**COMMISSION OF ARCHITECTURAL REVIEW**  
**APPLICATION FOR CERTIFICATE OF APPROPRIATENESS**

**Address** 420 N. 26th St (E0000384007)

**Historic district** Church Hill North

At the August 27 meeting staff recommended and the Commission discussed a number of recommendations. The specific recommendations and the responses to those recommendations are listed below.

## PROPOSED FLOOR PLAN

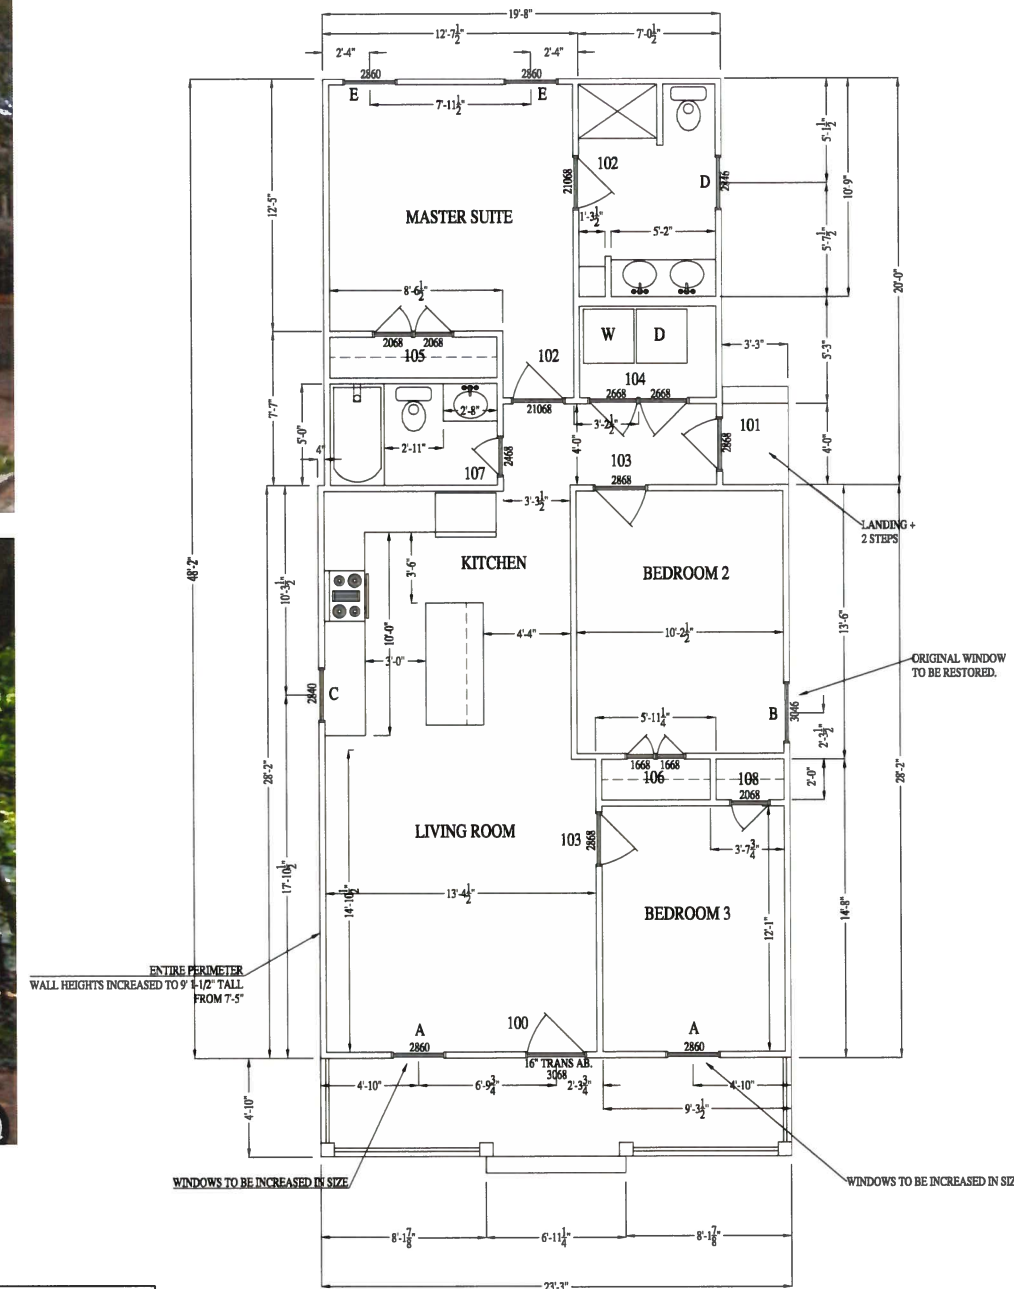
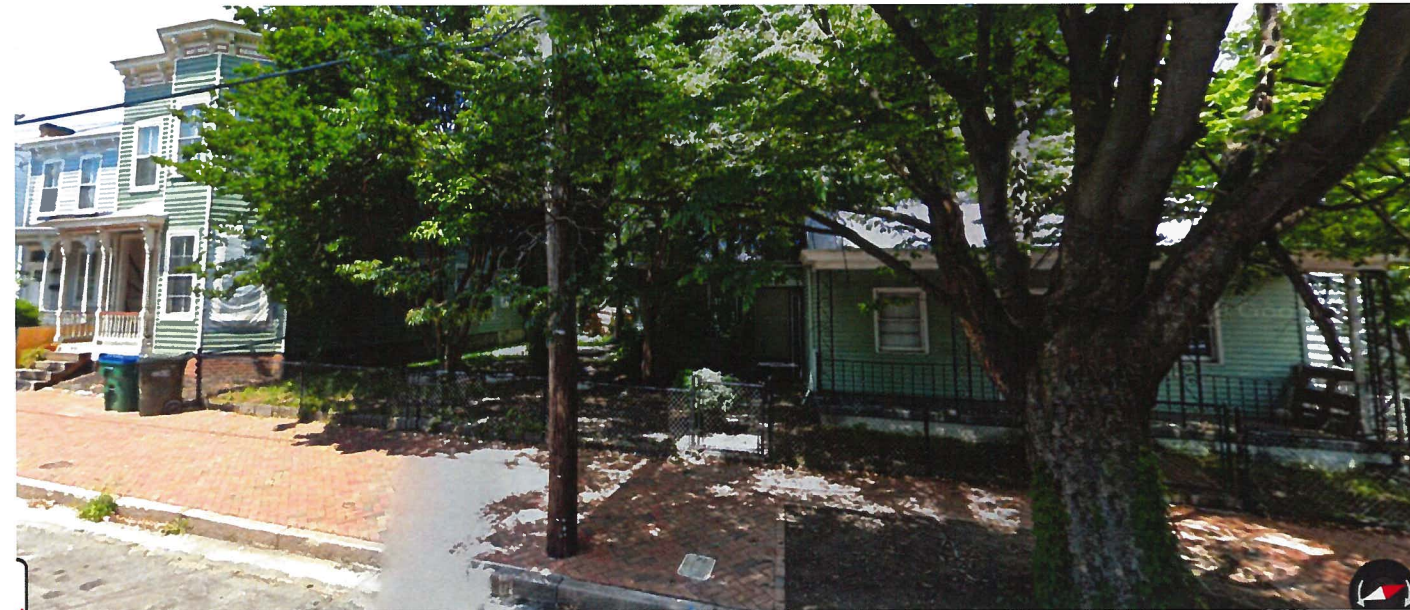
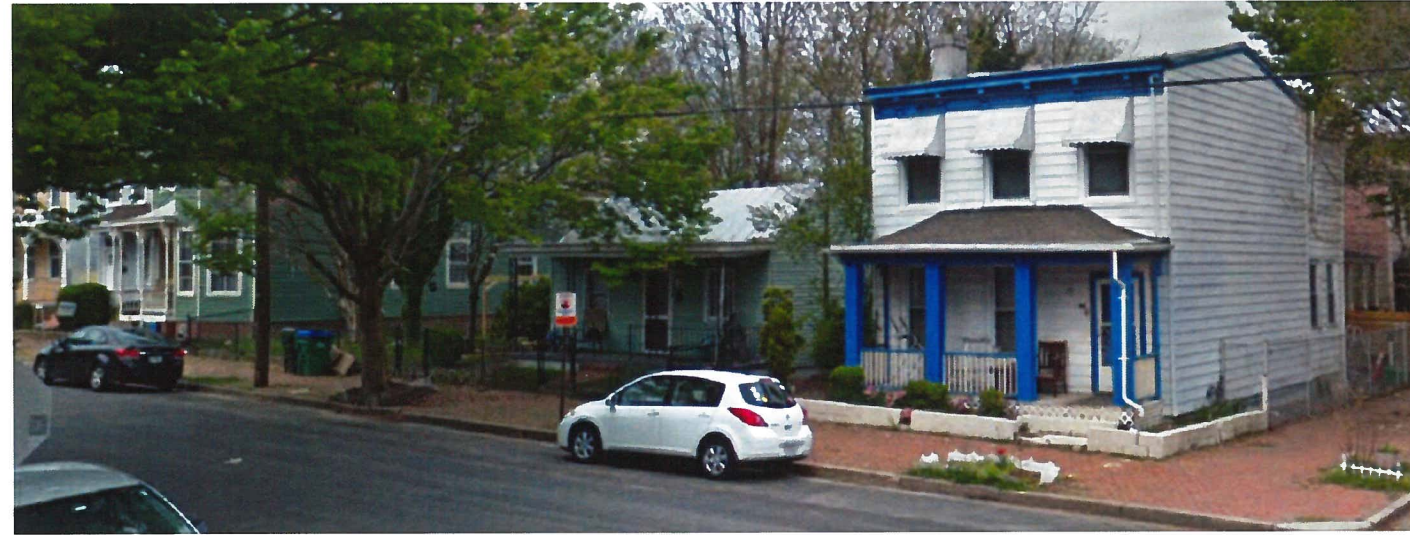
- the applicant inset the rear addition from the existing building, the width of a corner-board  
*The plans have been revised to address this.*

## CONCEPTUAL STREET VIEW PLAN

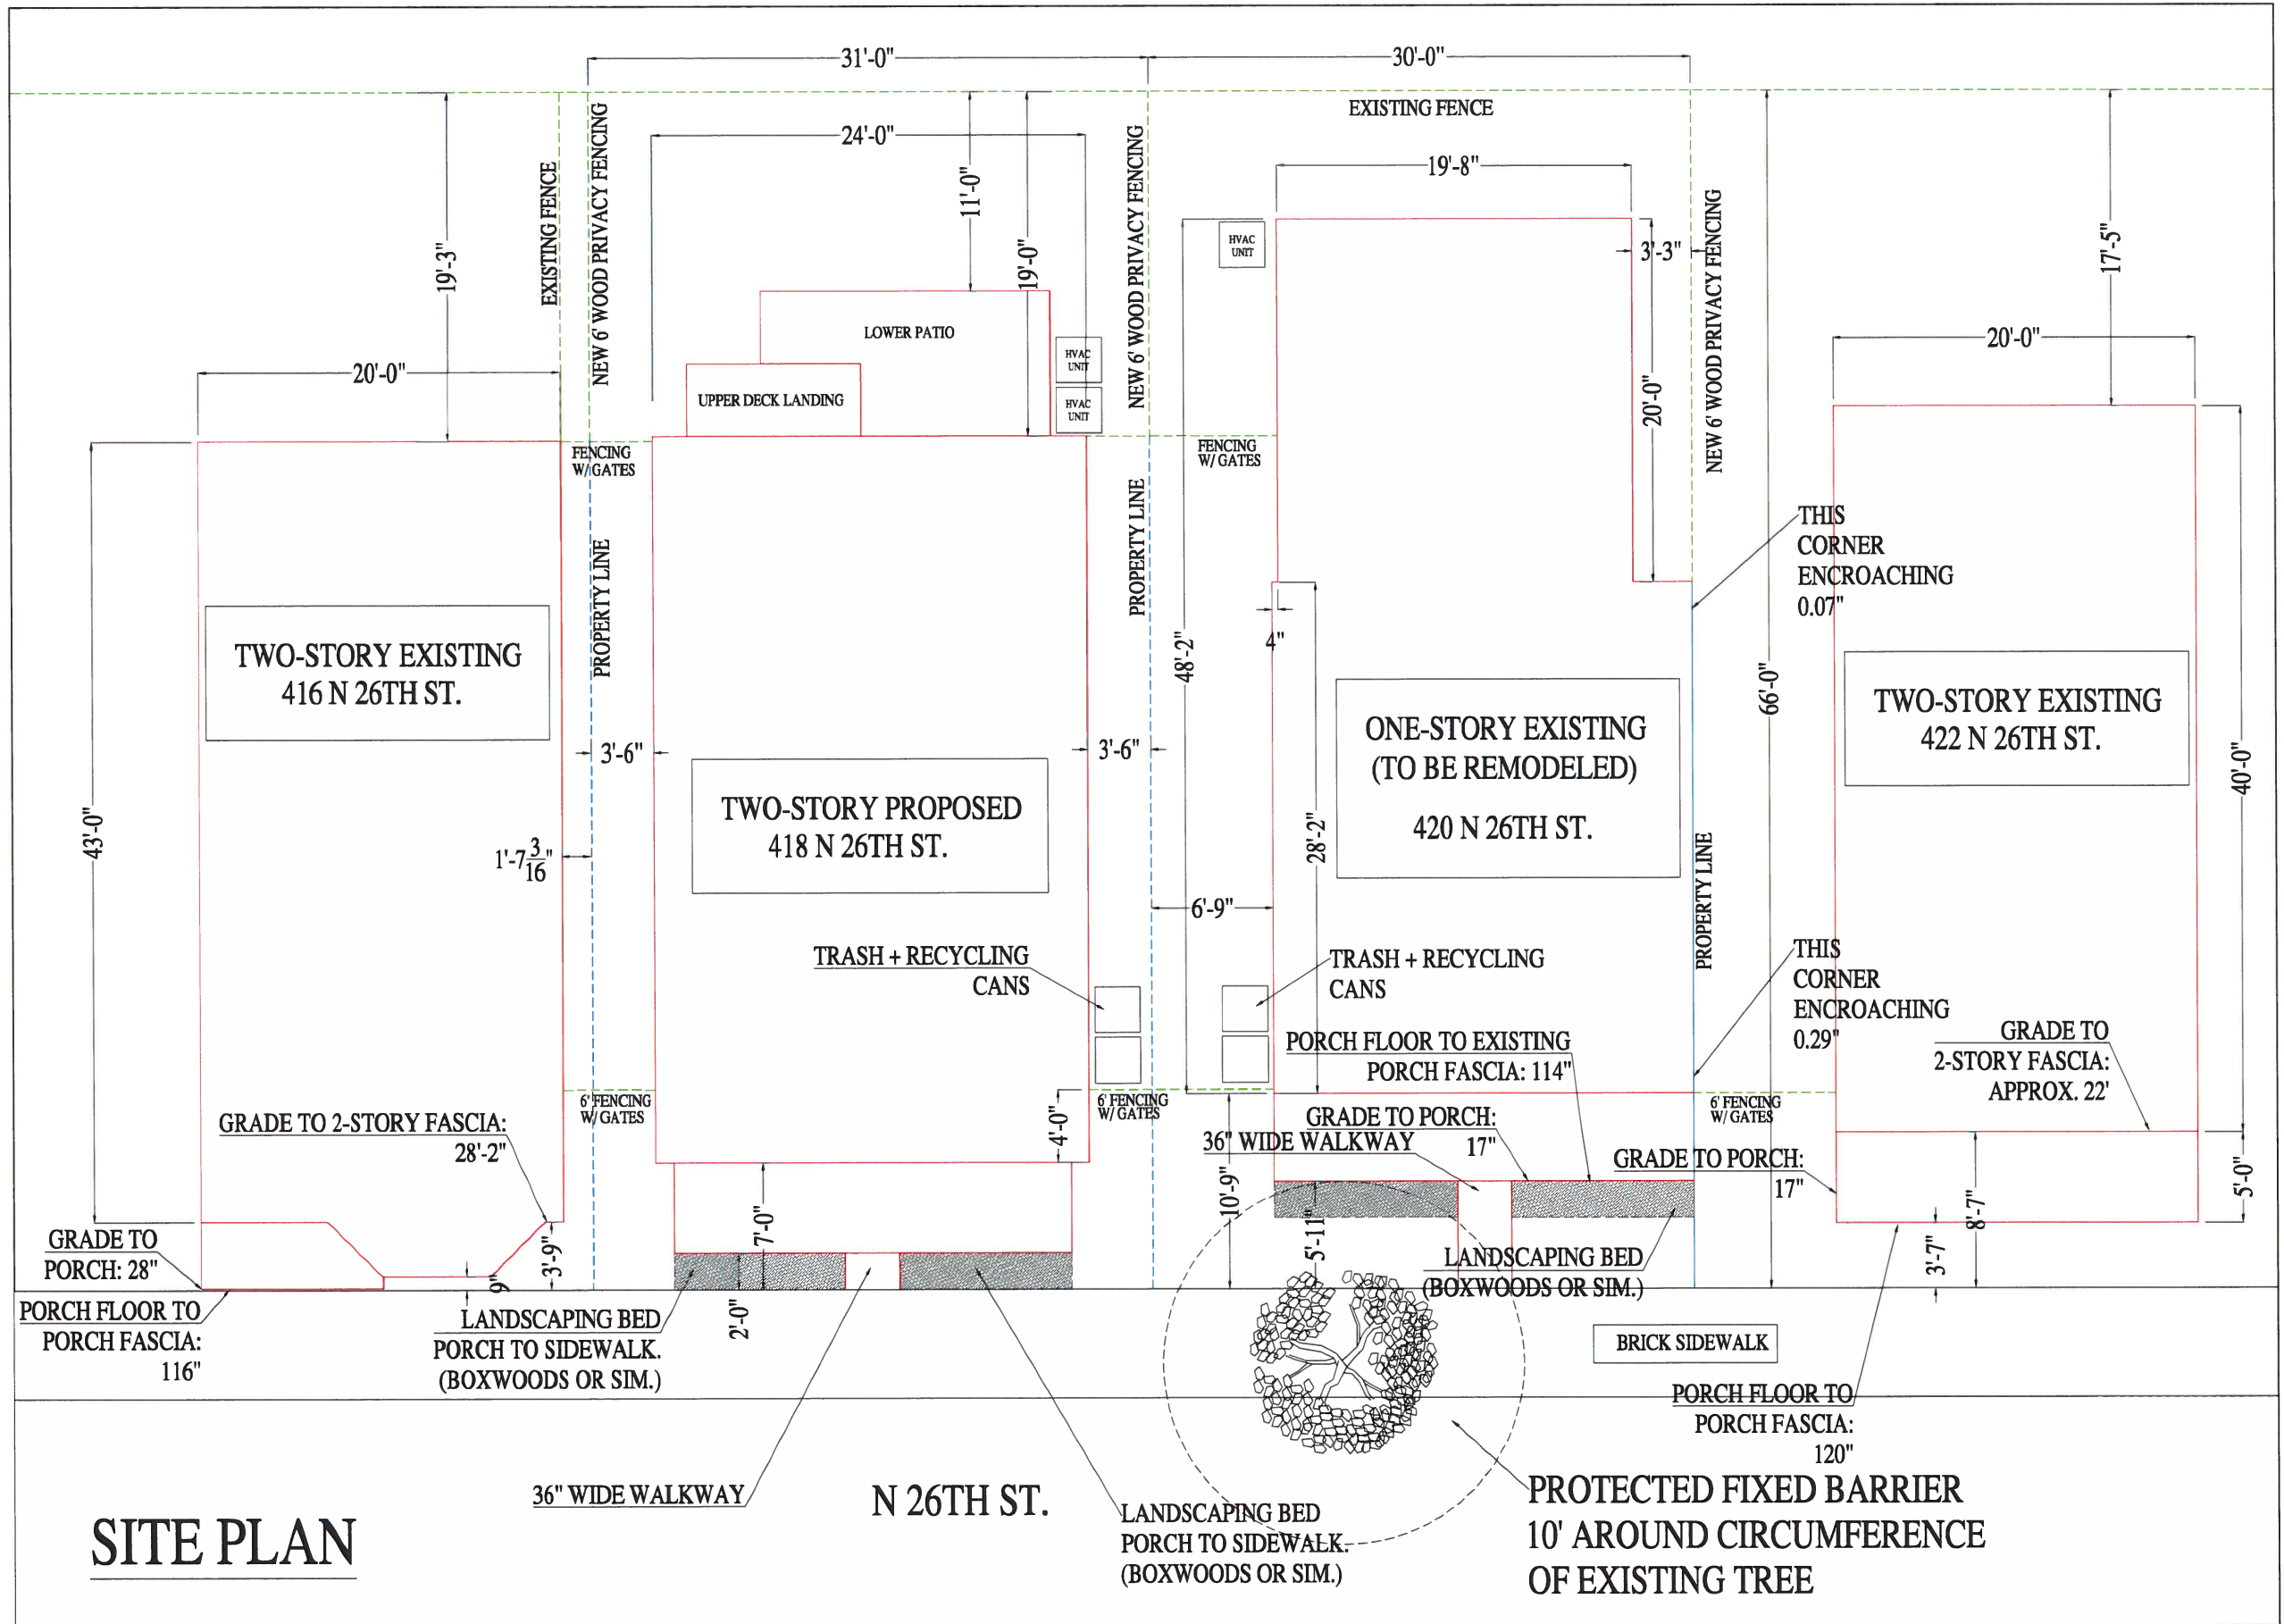
- A dimensioned context elevation for final review that includes the porch floor height, cornice line height and roof ridge height

A revised contextual exhibit is included with this request. The proposed dwelling is compatible in height with other structures in the vicinity, particularly in light of the revised roofline associated with this request. At 24', the proposed width of the new dwelling is consistent with the existing dwelling (23.5' +/-) and is compatible with the widths of other dwellings in the block. Beginning at 422 N 26<sup>th</sup> Street and moving south, the porch/first floor heights generally increase from at grade at the corner, to 1'6" at the existing dwelling on the property, to 2'4" +/- at the abutting 416 N 26<sup>th</sup> to the south. The proposed dwelling would have a first floor/porch height consistent with that context at 2'4". This matches the height of adjacent 416 N 26<sup>th</sup> given the lesser setback between that dwelling and the proposed dwelling.

*The context exhibit has been revised to include the requested heights.*
